INTER-DEPARTMENTAL REVIEW COMMITTEE REPORT

2 YORKTOWN CENTER – SUMMIT TOWNHOMES PHASE II

November 17, 2025

PC 25-14

Figure 4. Yorktown Center sign and Summit at Yorktown sign

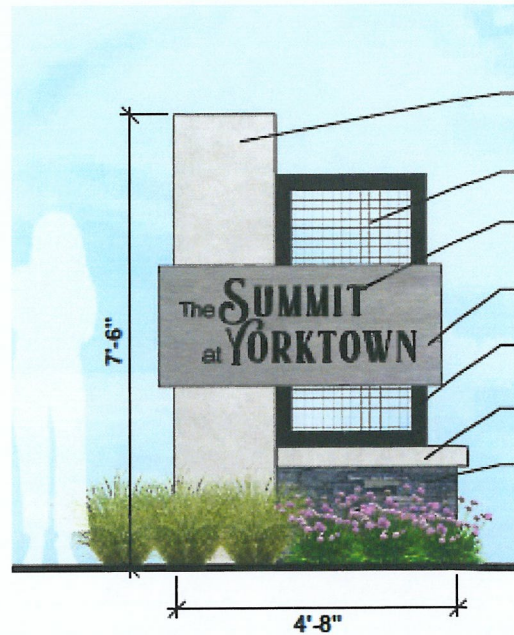
The petitioner proposes to install a monument sign and companion design element at the driveway entrance from the Yorktown Ring Road into Phase II. The proposed sign will be installed at 5'2" above grade (measured to the highest point of the sign face containing text). The maximum allowable height for project identification signs is four feet, measured from grade. The petitioner is requesting a deviation to allow for the sign at the proposed height.

The Phase II signage is identical to the signage used for Phase I of the development. The Phase I signage received zoning relief in 2023 (PC 23-08). As noted in the PC 23-08 IDRC report, the Summit signage is designed to complement the architecture of the townhomes as well as the larger monument signs located at the entrances to Yorktown Center (Figure 4). Staff further noted that the size of the Summit signs is similar to the size of the signs that were previously displayed on the property when it was developed with the Yorktown Convenience Center. For the sake of consistency, staff recommends the signage relief granted to Phase I in 2023 be extended to Phase II.
